## BOQ\_ANNEXURE\_2

## **PROJECT SPECIFIC DRAWING & DOCUMENT LIST**

DRG / DOC TITLE NTPC DRG / DOC NO.						
	9587-001-230-PVC-F-00	047A				
BHEL DRG/ DOC NO.	TB-423-316-005					
Revision	0					
Reviewed By	NTPC					
NTPC COMMENTS REF:	CC-ENGG-9587-001-230-PVC-F-0047A, DTD. 20.05.2024					
1 1 1 1 1 1 1 1 1 1 1 1 1 1 1 1 1 1 1	400kV AIS SWITCHYARD					
Page No. / Clause No. / Sheet No.	NTPC Observations / Comments dtd. 20.05.2024	BHEL Reply dtd 07.10.2024

2 X 800 MW NTPC LARA STPS STAGE-II EPC

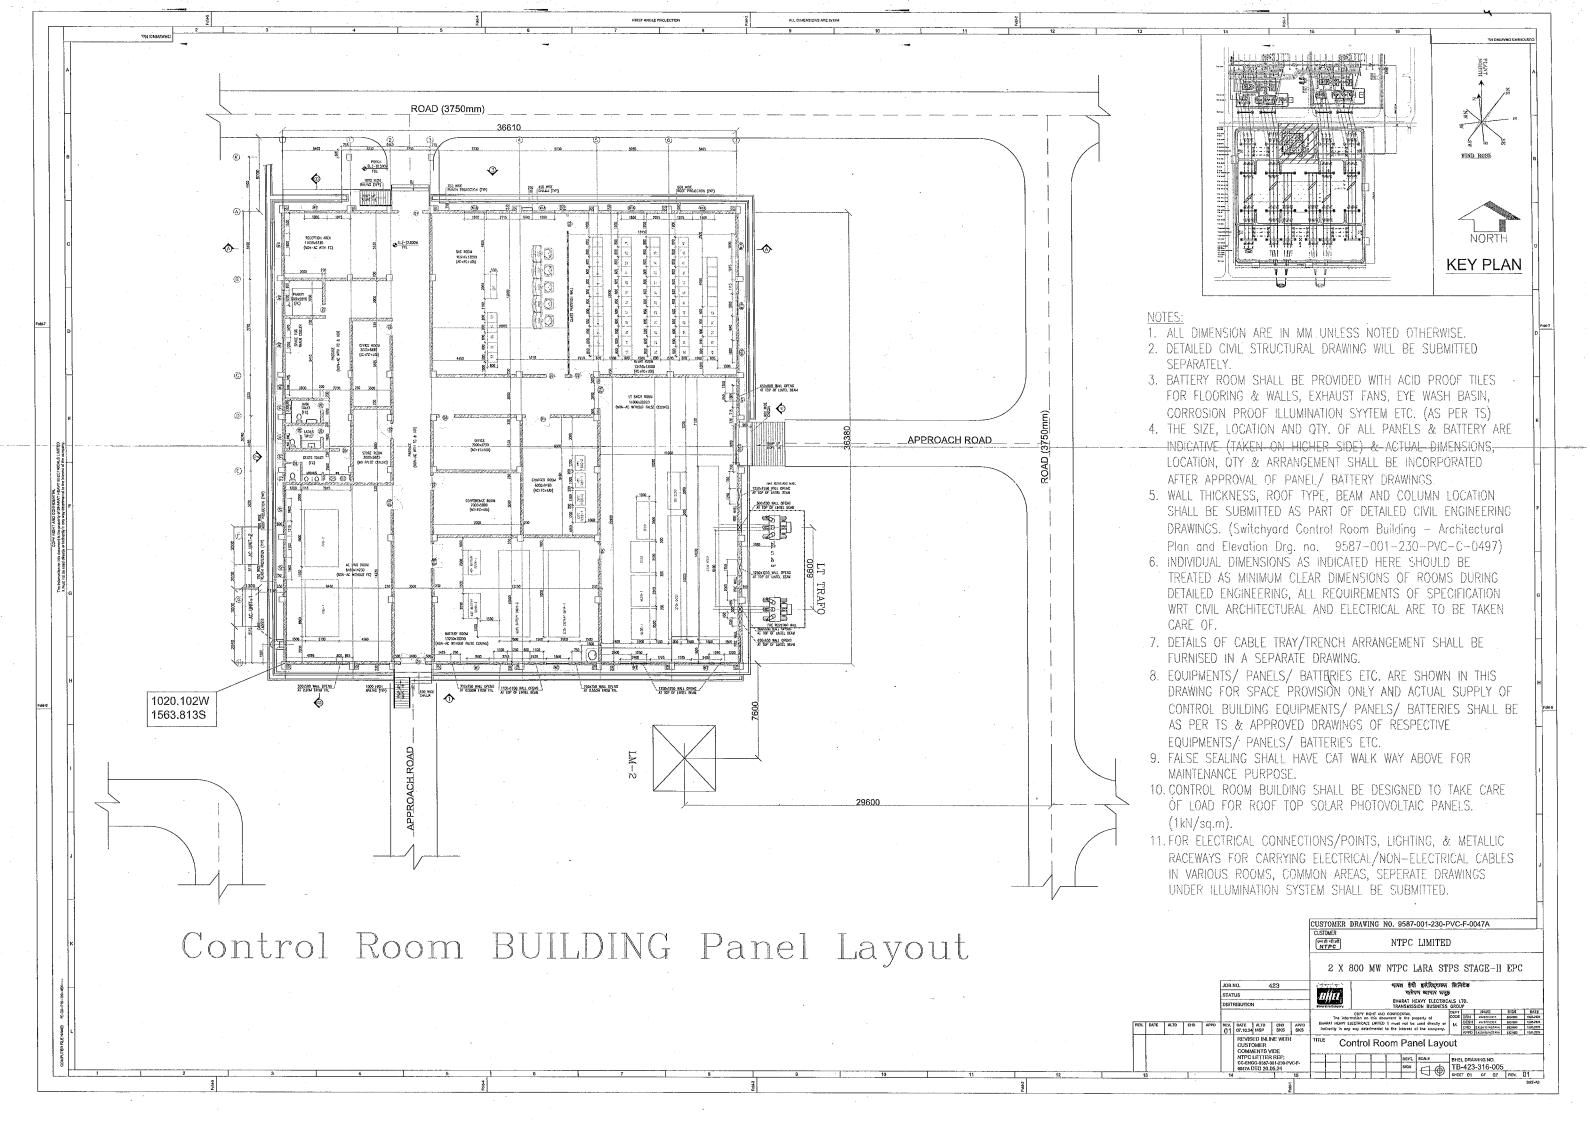
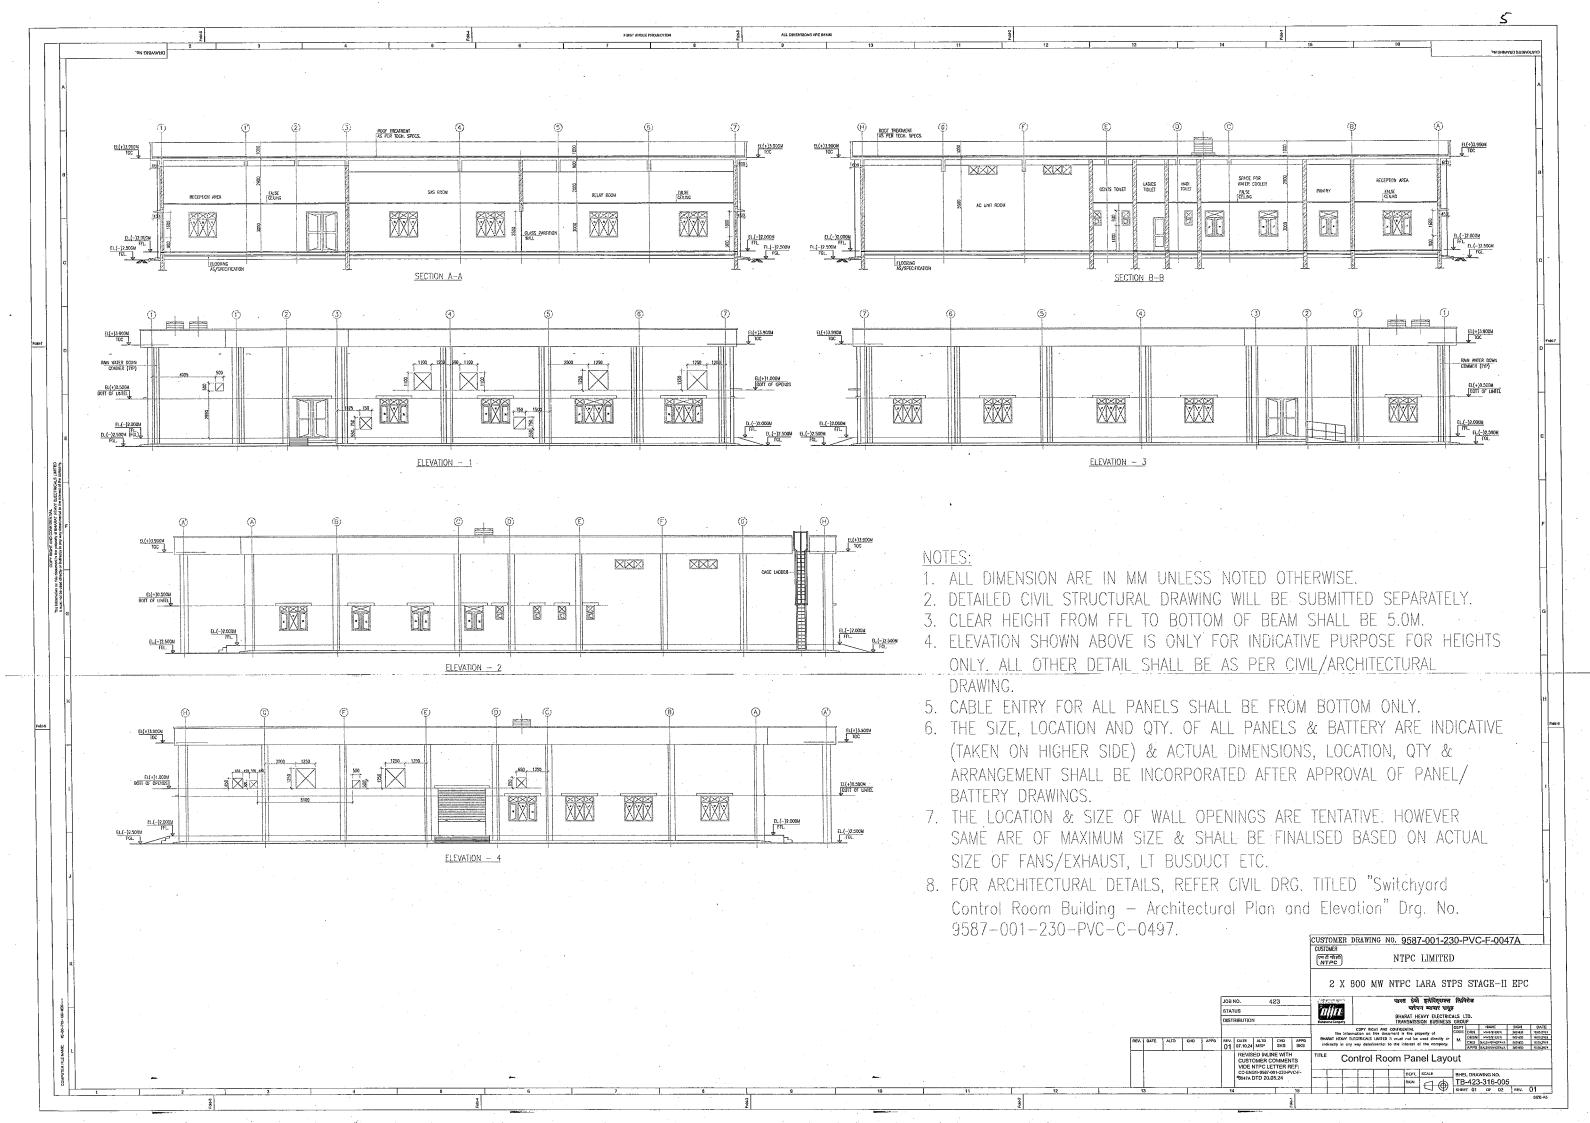
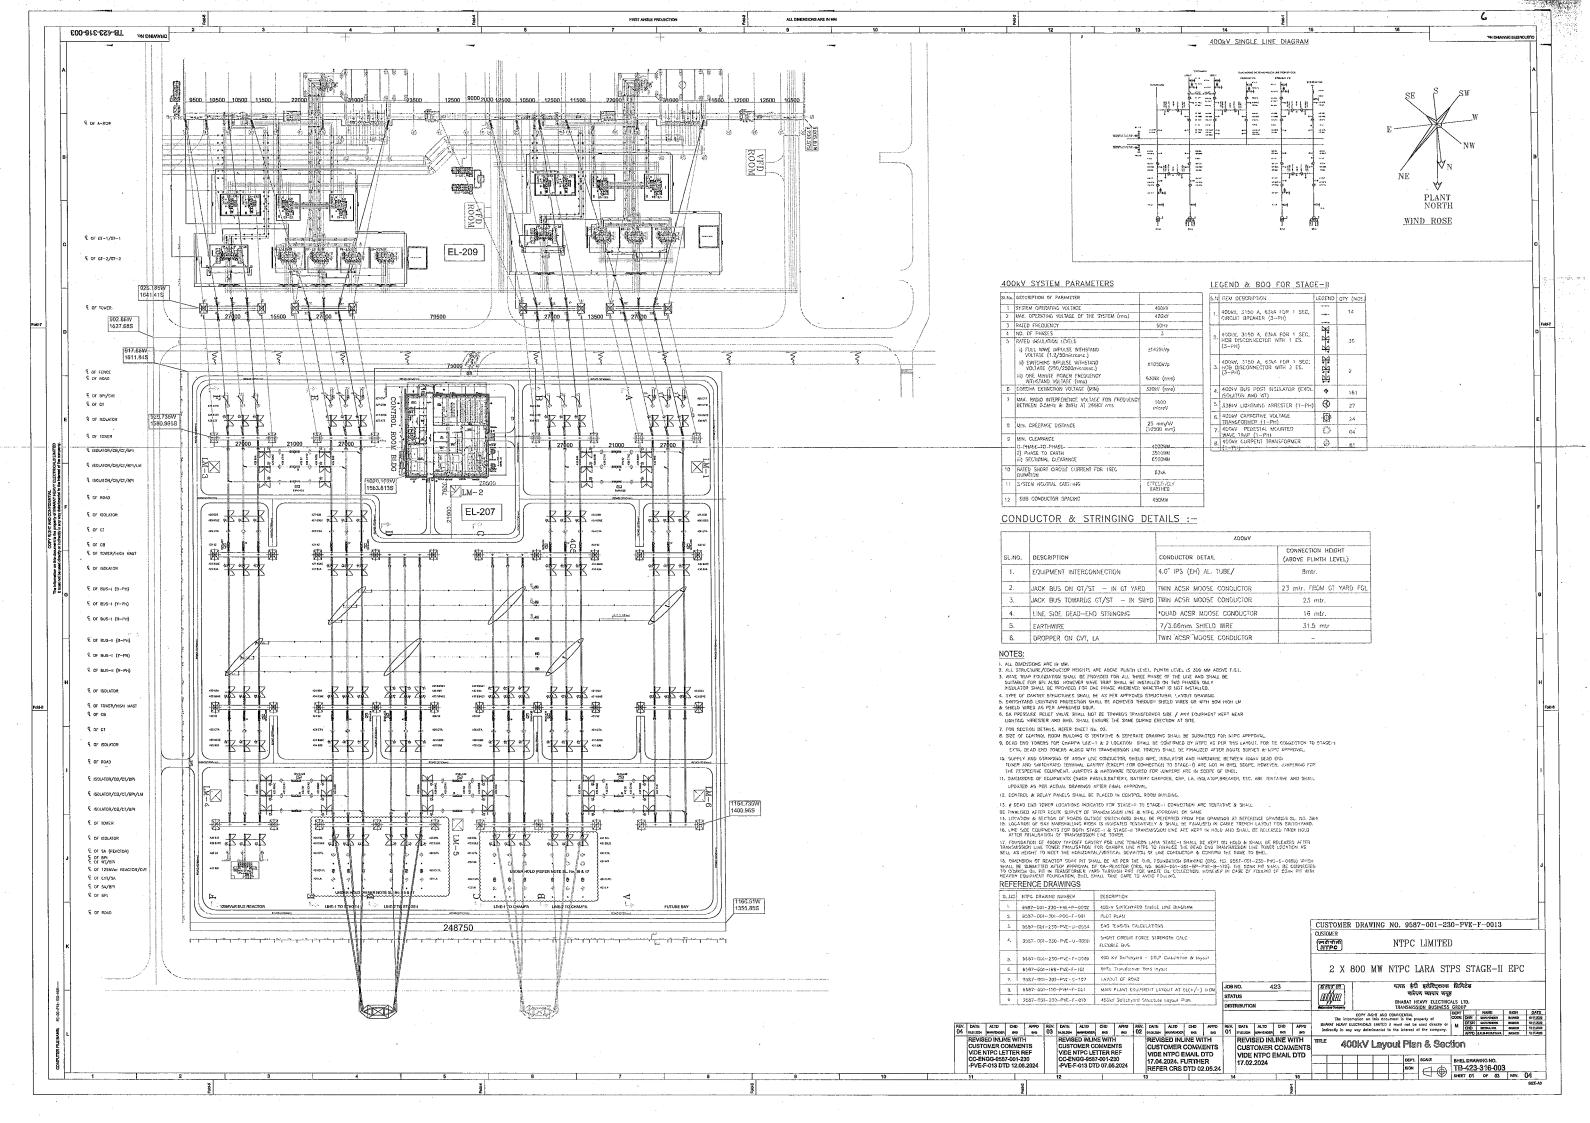
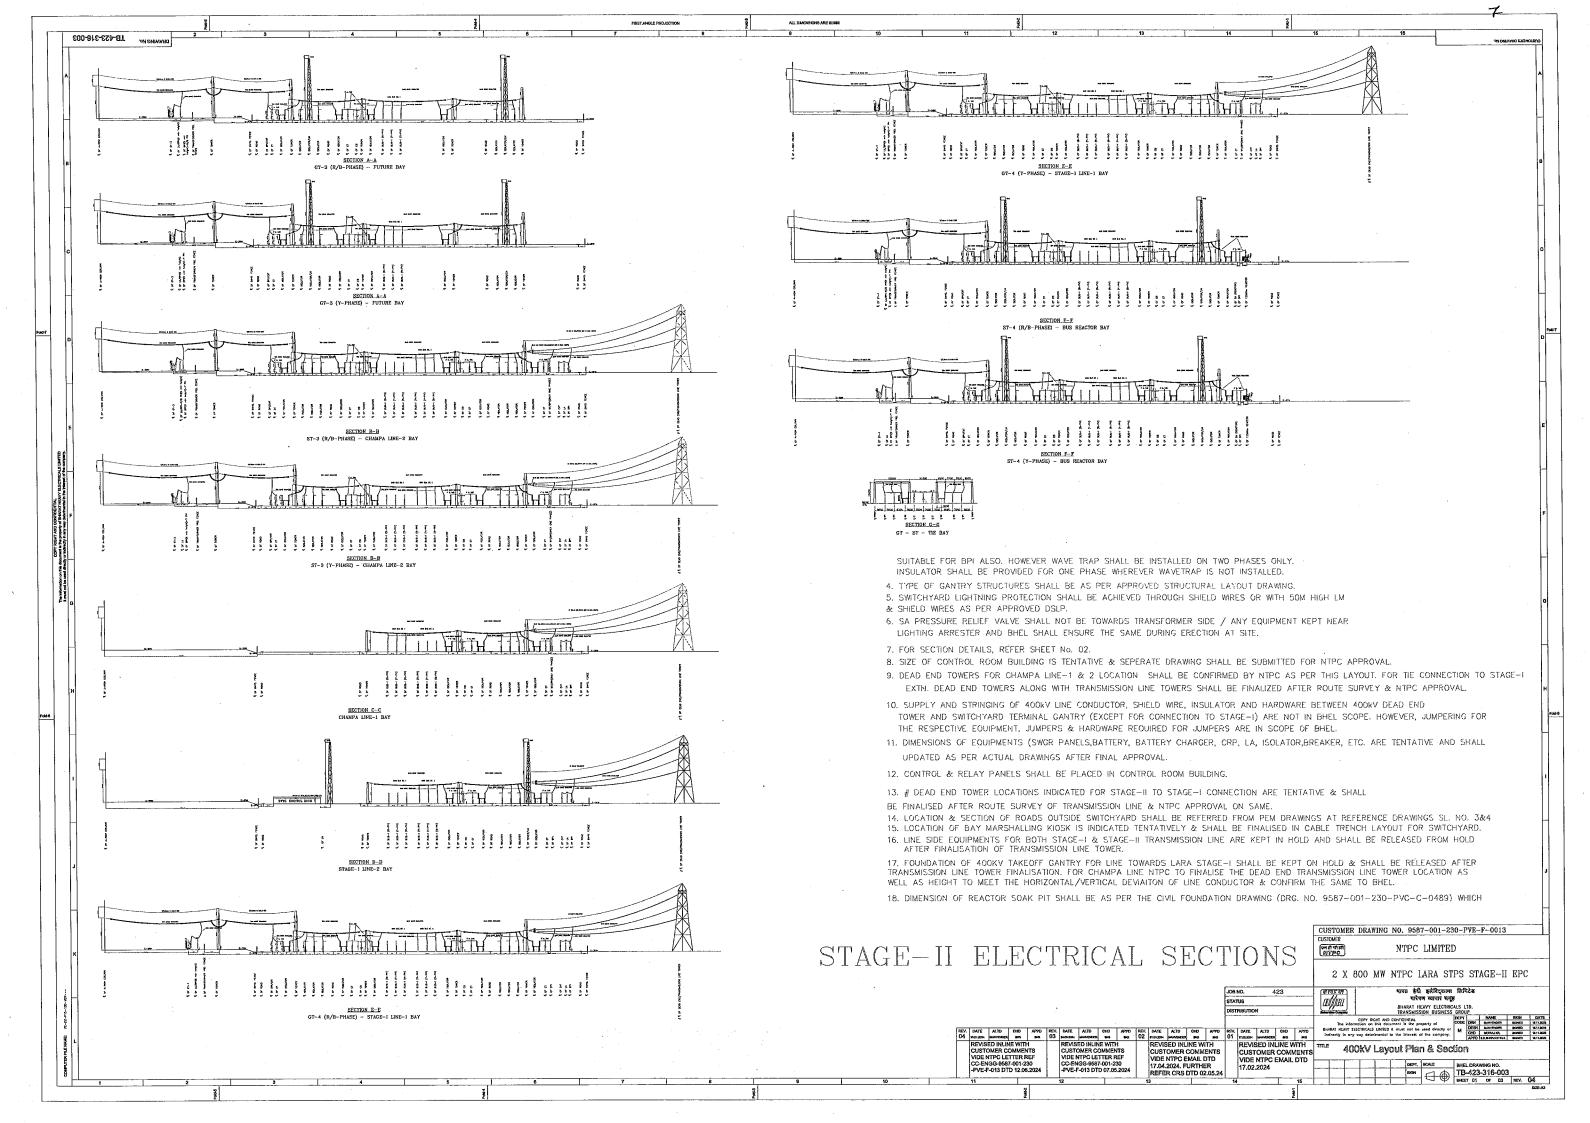
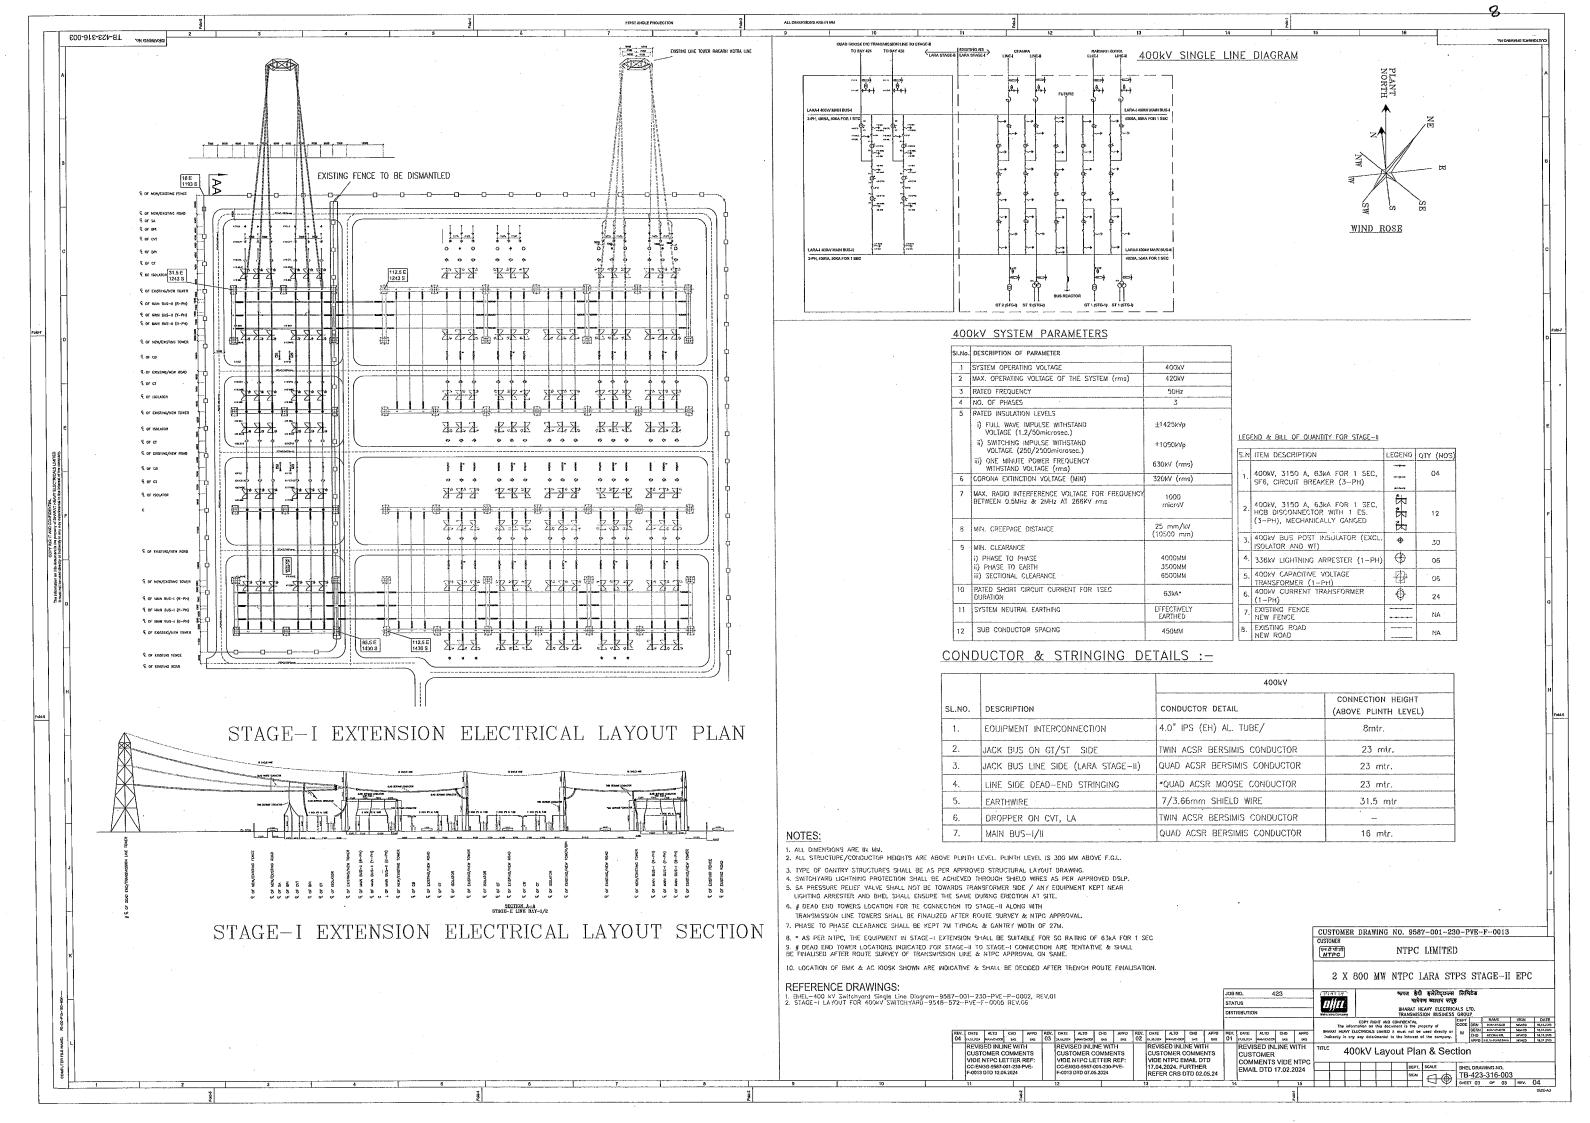
Sheet 1 of 2	a) Show approach road to Porch for access.	a) Confirmed & incorporated in the revised document.				
	b) Also check for Lighting provision and concealed lighting in this area	B) The same shall be taken care during Illumination system drawings for Control room buildin which shall be submitted seperately.

Sheet 1 of 2	Provide access to reception area	Confirmed & incorporated in the revised document				
Sheet 1 of 2	Provide rolling shutter in LT SWGR room with approach road	Confirmed & incorporated in the revised document

Sheet 1 of 2	Provide fire door in LT SWGR room	Confirmed & incorporated in the revised document				
Sheet 1 of 2	Requirement of fence with gate to be checked for LT Transformer area	Confirmed & incorporated in the revised document

Sheet 1 of 2	Indicate space between DB's & clearance from walls	Confirmed & incorporated in the revised document				
Sheet 1 of 2	Wall toward LT Transformer shall be 350mm thick fore resistant wall	Confirmed & incorporated in the revised document

Sheet 1 of 2	Mark reference drawings for Note SL. No. 4,5 & 7	For Note SI. No. 4 drawing no shall be marked after purchase order placement for Battery,				
		charger, panels, etc. For Note SL. No. 5, reference Civil drawing marked. For Note SL. No. 7, the Drawing no is not available in NTPC MDL as of now. Same shall be

Sheet 1 of 2	Also check for metallic raceways on floor for carrying IT/LAN & non electrical cables particularly in office room, conference room, seating area, reception etc. 'Check for provision of electrical points in seating area, office area, conference room, pantry etc. or add note or mark reference drawings	The same shall be taken care during Illumination system drawings for Control room building which shall be submitted seperately.				
) Sheet 2 of 2	a) False sealing of mineral fibre board, GRG board, calcium silicate or metal shall be as per internal finishing schedule at Table A of technical specification and approved architectural drawings.	a) For details, please refer Civil Switchyard Control Room Building - Architectural Plan and Elevation Drg. no. 9587-001-230-PVC-C-0497.

b) Underdeck insulation shall be provided on the ceiling (underside of roof slab) and underside of floor slab of air conditioned area depending on functional requirements. The under deck insulation shall consist of 50mm thick mineral wool insulation with 0.5mm thick aluminium foil & 0.6 mm X 25mm mesh wire netting & shall be fixed to	drawing. However for technical details, please refer Civil Switchyard Control Room Building				
	ceriling with 2mm wire ties.  c) Suitable cut-outs shall be provided in false ceiling to facilitate fixing of lighting fixtures, AC grills, smoke detectors, etc.	c) Confirmed & same shall be taken care inline with actual lighting fire fighting layouts.  d) Confirmed. However please refer Civil Switchyard Control Room Building - Architectural Fand Elevation Drg. no. 9587-001-230-PVC-C-0497.

d) As per technical specification, Control room false ceiling shall have catwalk way above for maintenance. Please ensure the same.	e) PLease refer our reply on above point SL. No. 9.

e) Mark reference drawing to Architectural drawing, internal cable trench layout drawing.
